**Petition 1566**  
**Interrogatories for Eversource Energy**  
**Submitted by Cory Spaulding and Leslie Yeisley**  
**July 6, 2023**

**RE: PETITION NO. 1566** - The Connecticut Light and Power Company d/b/a Eversource Energy petition for a declaratory ruling, pursuant to Connecticut General Statutes §4-176 and §16-50k, for the proposed Card Substation to Wawecus Junction Upgrade Project consisting of the replacement of electric transmission line structures along its existing 12.5-mile electric transmission right-of way shared by its existing 115-kilovolt (kV) Nos. 1080/1490 and 1080/1070 Lines between Card Substation in Lebanon, Stockhouse Road Substation in Bozrah and Wawecus Junction in Norwich, Connecticut traversing the municipalities of Lebanon, Franklin, Bozrah and Norwich, and related electric transmission line and substation improvements.

## PHOTO #2 - Year 2019 - Site 7785

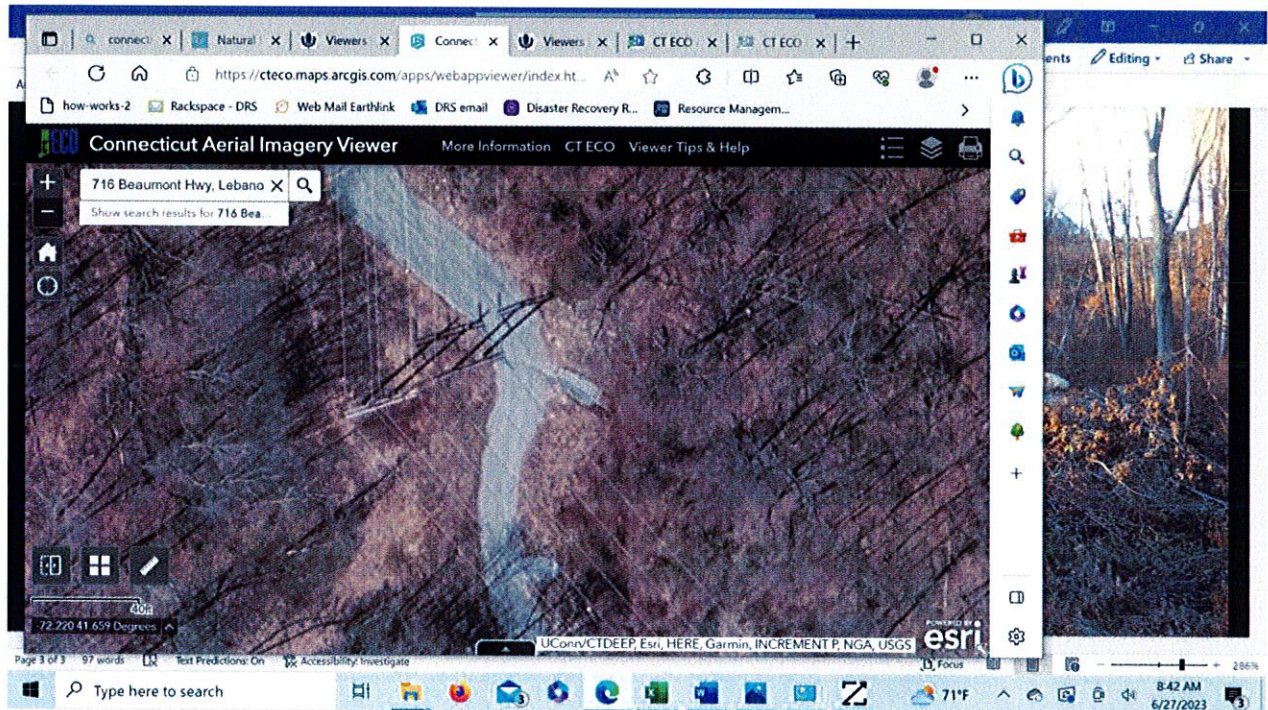
- 1) How many transmission line support poles existed at site 7785 in 2016 thru 2019? I have attached photos 1 and 2 taken in 2016 and 2019 to assist you in answering.

- 2) Are the number of support poles that existed in 2016 thru 2019 at site 7785 correctly depicted in photos 1 and 2 attached and do you agree that 4 support poles existed at this site in 2016 thru 2019?

- 10) Does photo number 2 accurately depict the path of this gravel / stone road as it existed in 2019 as it traverses thru site 7785?
- 11) In 2021 you performed work at site 7785. When you performed that work did you change the route of this road from its configuration in 2019? You can use photo 2 from 2019, photo 3 and 4 from December of 2021 to assist you in answering this question. If YES, did you notify the Council and the property owner of the route change and when did the Council approve this route change? If NO, please explain how the route did not change?

**PHOTO # 3 - YEAR -December 20, 2021 – SITE 7785**

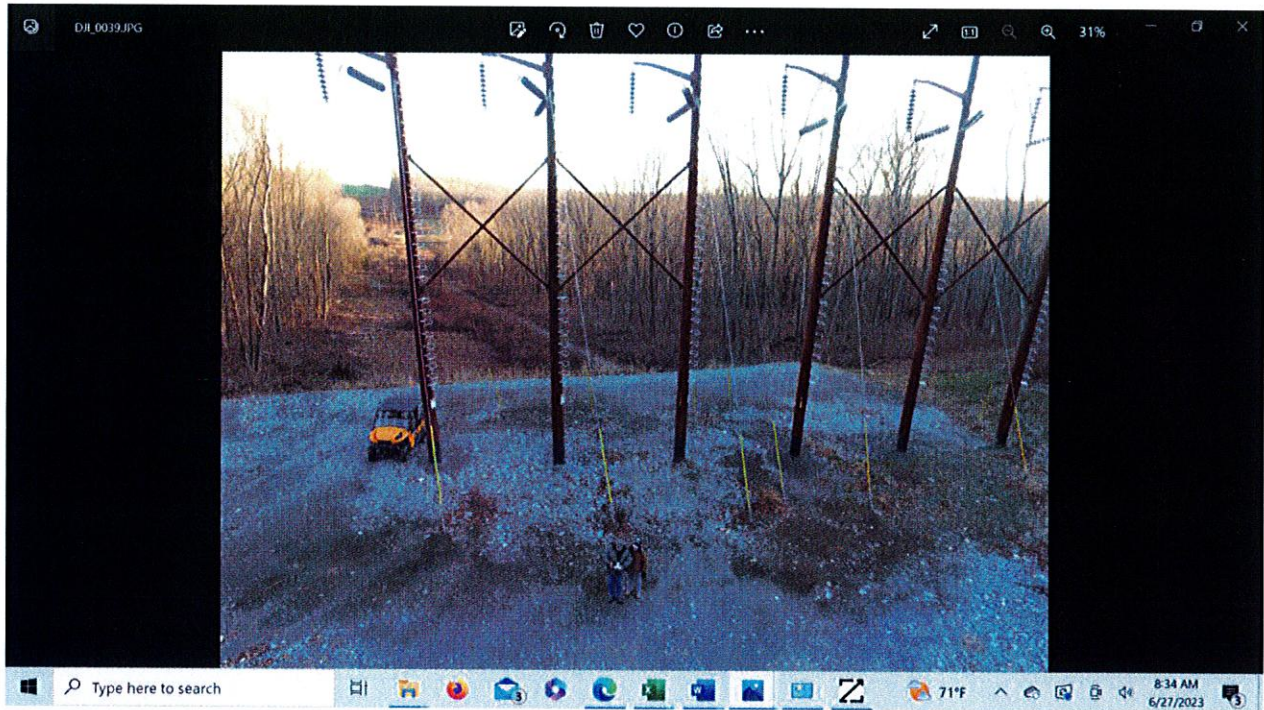
- 3) You have stated in your response to motions to dismiss on pdf page 8 that you “replaced wood angle structures #7785 and 7785A on Lines 1490 and 1080, respectively, which were non-jurisdictional”. You also stated on this page that this work was performed between May of 2021 and September 15, 2021. When you replaced the wood angle support structures between May and September of 2021, how many new support structures did you install at site 7785? I have attached photos 3 and 4 taken in December of 2021 to assist you in answering.

- 4) Are the number of support poles that you replaced accurately depicted in photos 3 and 4 attached and do you agree that 6 support poles were installed by you in 2021 at this location?

- 14) Please explain why the large pad and road configuration depicted in photos 3 and 4 of site 7785 are not shown or depicted in map 6 of 24 in petition 1566 which is photos 6 and 8?

# PHOTO # 5 -Map 5 of 23 – Sub Petition 1293 LFBNM-01 – July 17, 2017

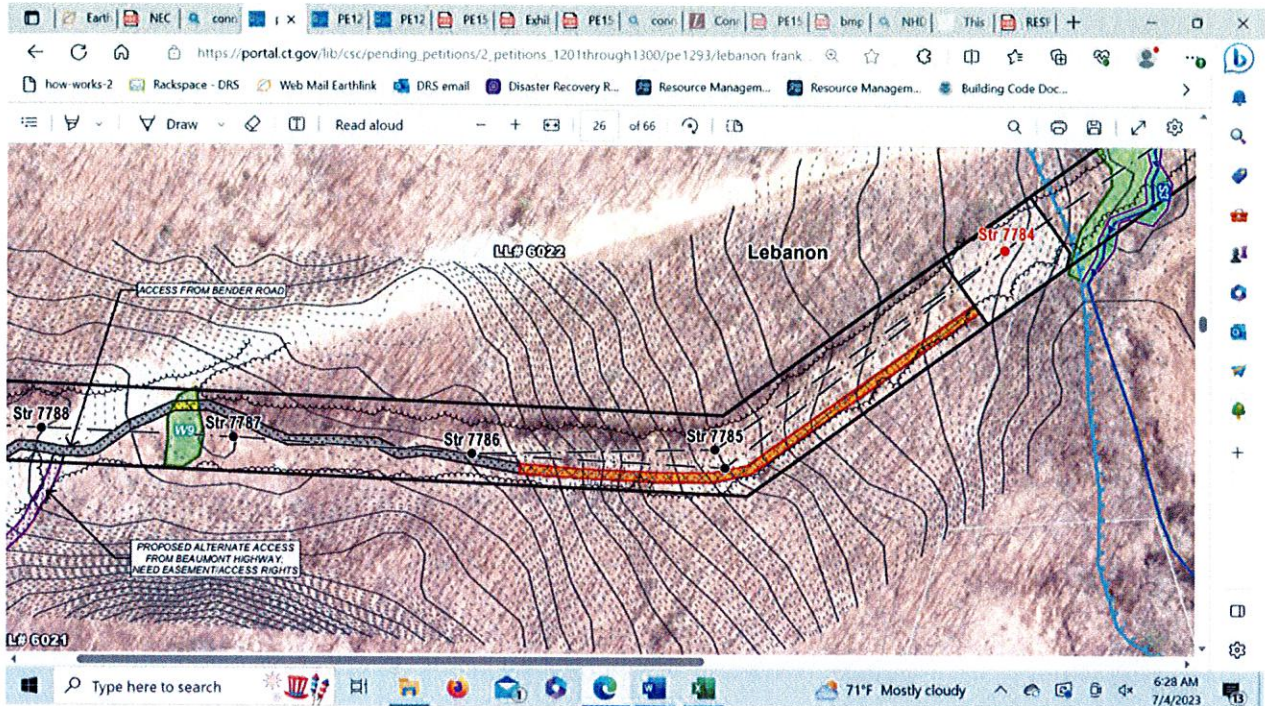
- 9) In Sub Petition 1293 LFBNM-01 the Siting Council authorized you to install a mat road from site 7786 to site 7784. That mat road generally followed the westerly side of the ROW and is depicted in photos 5 and 7. Instead of a mat road you installed a stone/ gravel road. This is depicted in photos 6 and 8. Did this gravel / stone road that was installed follow the same route as authorized by the Council in Sub Petition 1293 LFBNM-01? If NO, when did you notify the Council of the route change and when did the Council authorize the change in the route?

# PHOTO # 6 - Petition 1566 Map 6 of 24 – Dated April 11, 2023

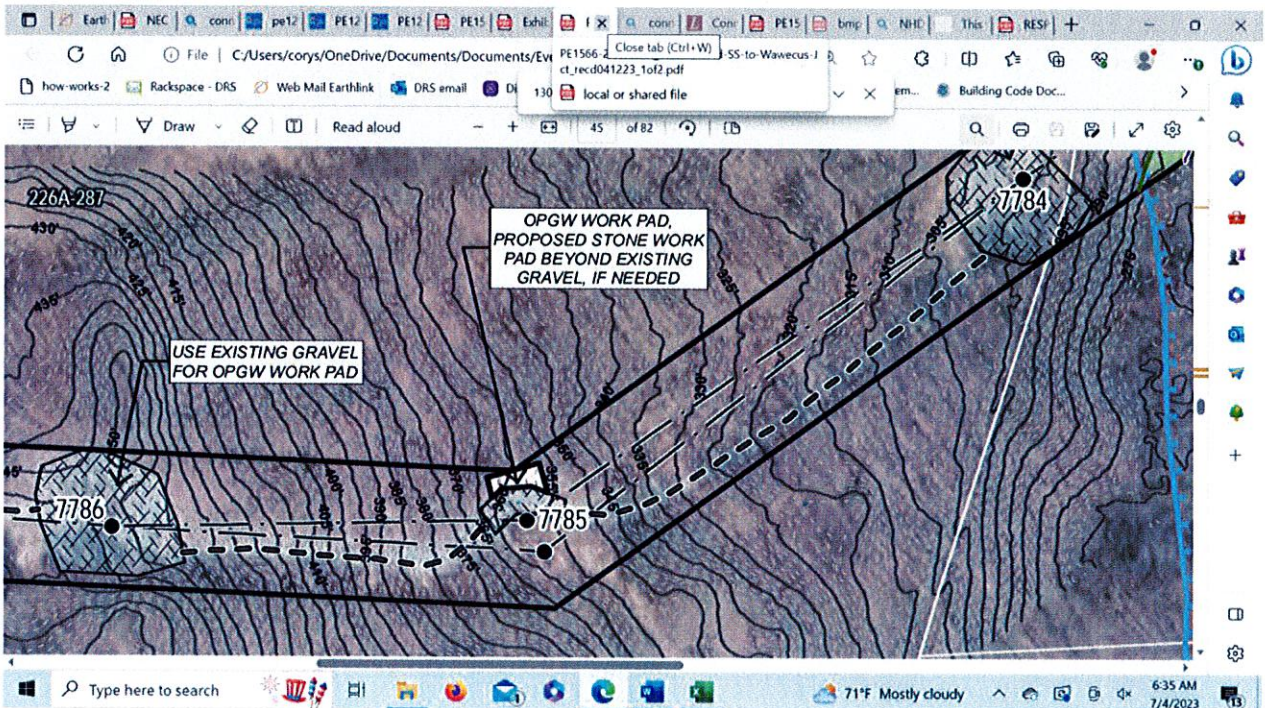
- 12) Photo 6 is map 6 of 24 that you submitted in petition 1566. That map has a date of April 2023. This map uses an aerial view overlay. What year does this aerial overlay depict and what is the source of this base map? Do you agree that the overlay is a 2019 aerial view?

- 13) Do you agree that the submitted map 6 of 24 in petition 1566 represents the road configuration that existed in 2019 and not what road configuration that presently exists? You may use photos 2, 3, 4, 6, and 8 to assist you in answering the question.

- 15) Utilizing Exhibit 10, a site survey map of site 7785 dated 4/15/22 drawn by Rob Hellstrom Land Surveyor, and photos 6 and 8, please explain why the site characteristics and topo lines depicted in the survey map are not the same as the site characteristics and topo lines that you submitted in map 6 of 24 in petition 1566?

# PHOTO # 7 -Map 5 of 23 – Sub Petition 1293 LFBNM-01 – July 17, 2017

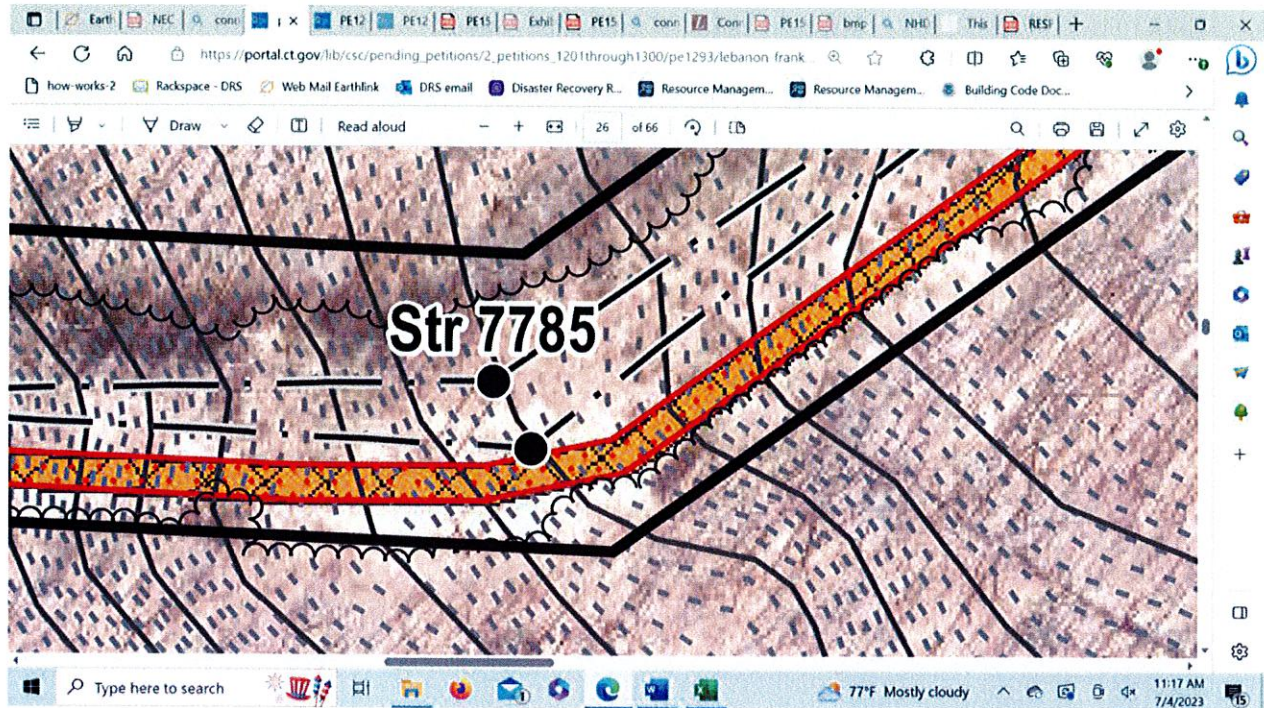
- 17) Can you please explain why the topo map lines that you submitted in map 6 of 24 dated in petition 1566 for site 7785 (photo 7) which is supposed to depict present 2023 conditions is nearly identical to the existing topo lines from 2017 as depicted in Sub Petition 1293 LFBNM-01 map 5 of 23 (photo 8). You can use photos 7 and 8 to assist you in your answer.

# PHOTO # 8 - Petition 1566 Map 6 of 24 – Dated April 11, 2023

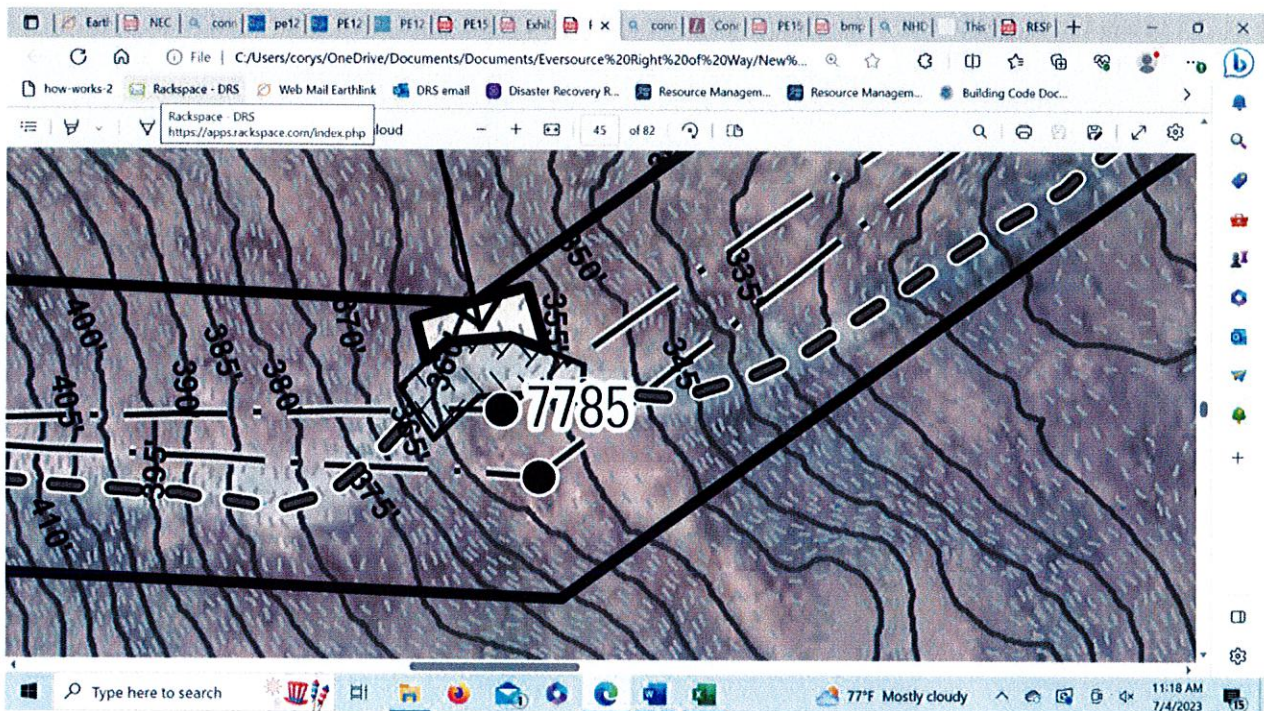
- 16) Do you have any explanation as to why the Exhibit 10 survey map details the near level area near the 6 transmission line support structures as extending to the bounds of ROW and beyond on both sides of the ROW, where map 6 of 24 in petition 1566 as depicted in photos 6 and 8 does not depict this same site feature?

# Exhibit 10 – Site 7785 - Rob Hellstrom Land Surveyor – 4/15/22

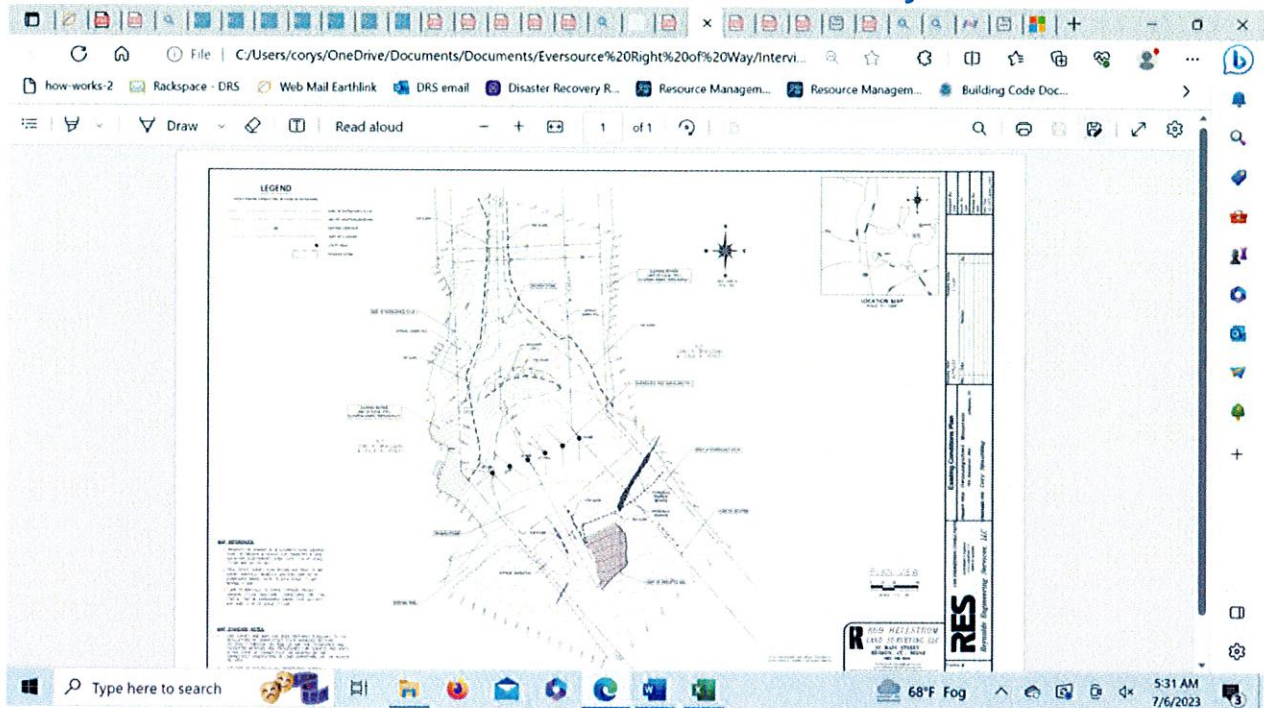
- 43) Please explain why petition 1566 map 6 of 24 for site 7785 depicts a proposed area that may need a stone pad installed when Hallstrom Land Surveyors in Exhibit 10 has already identified that you presently have an existing pad in this exact location? Why does your petition 1566 submitted map not identify the existing pad at site 7785?

# Exhibit 1a-5 topo changes- 2017 to 2022 – Site 7785 - Rob Hellstrom Land Surveyor – 4/15/22

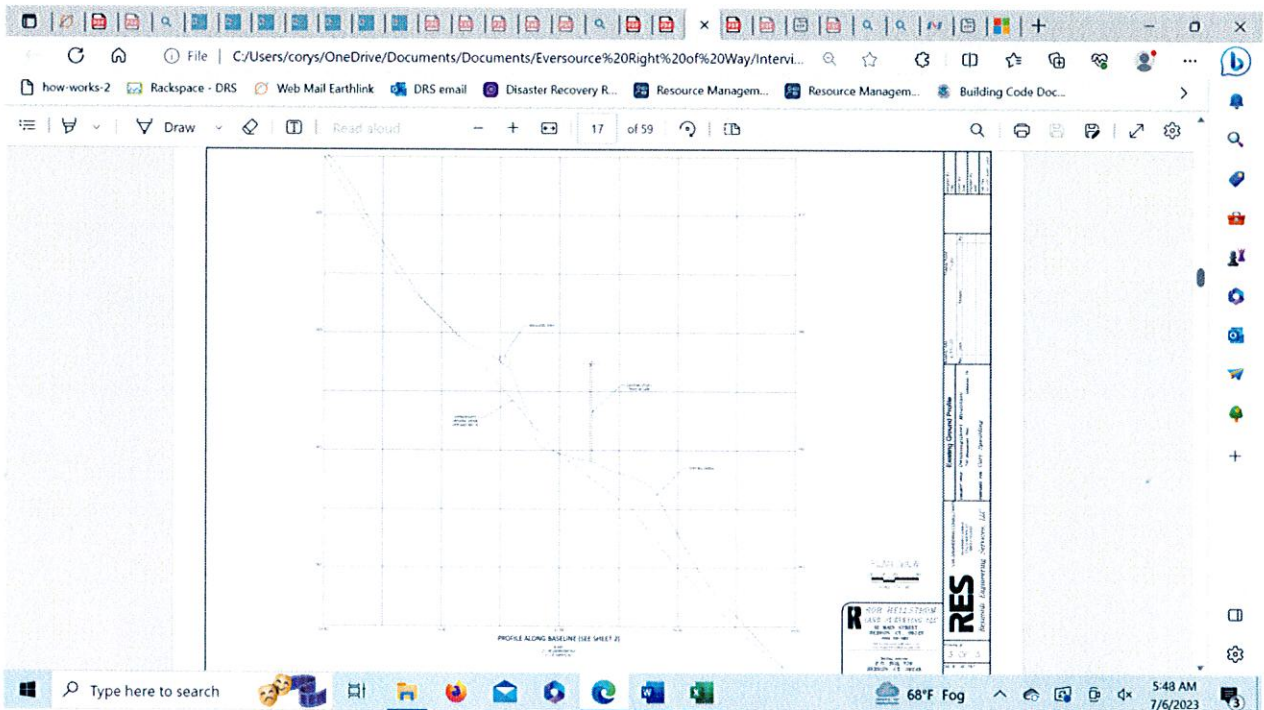
- 18) Can you please explain why the survey maps that are Exhibits 10 and Exhibits 1a-5 and photo 1 when compared to photos 2,3 and 4, show drastic changes in the land topography at site 7785 from what existed in 2017 but map 6 of 24 in petition 1566 dated April 2023, does not appear to reflect these topography changes?
